Staff Report & Recommendation

Design Review Board

SUBJECT: DRB19-0374
5324 Pine Tree Drive

The applicant has submitted plans entitled "Pine Tree Residence", as prepared by **Beilinson_Gomez Architects PA**, dated 04/08/2019.

Portion of the 1924 Plat of Beach View Subdivision (subject property Lot 3 Block 6)

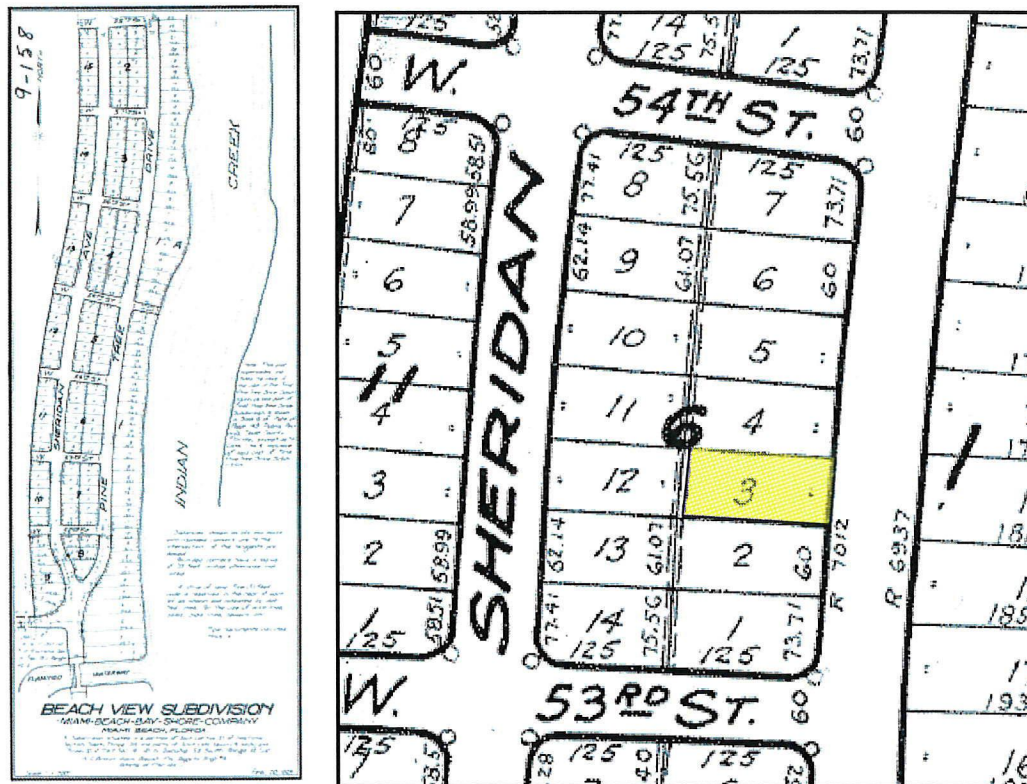
The minimum required setback on both sides is 10'-0". The applicant is proposing a 7'-6" south side yard setback, as if the property were 60'-0". The front property line was platted with 60'-0' of length, along this slightly curving portion of Pine Tree Drive. The rear property line measures 61'-0". This results in consideration of this parcel as a lot greater than 60'-0"

in width; therefore, both interior side yards have a minimum requirement of 10'-0". These two (3) variances are related to the same zoning regulation. The subject property is an interior lot on a block within the Plat of Beach View Subdivision, which was historically platted on February 20, 1924 as a series of seven blocks west of the Indian Creek Canal, north of Flamingo Waterway and ending at 58th Street. The subject property is part of the subdivision, Lot 3, and was platted with a frontage of 60'-0" and a rear width of 61'-0". The recent changes to Section 142-106 pertaining to side setback requirements require that lots with over 60'-0" in width have an increased setback of a minimum of 10'-0" along both side yards. Lots with 60'-0" or less of frontage have a minimum of 7'-6" required side setback.

This would require the subject property, with less than 4" (or 60'-3 13/16") of additional frontage, to offset the building envelope an additional 5'-0" (2'-6" for each side). Staff finds that the request is 'de minimus' and that without the granting of this variance, the construction of the building on the lot would be more restrictive than its immediate neighbors and the site could not be developed as other lots in the same district and same platted subdivision the variance could be granted. The proposed setback of 7'-6" on one side is consistent with the existing setback conditions for the other surrounding properties. Therefore, the applicant's request would not create a negative impact upon the neighboring properties. The size of the property and its current parallelogram shape are the same original parcel geometric configuration.
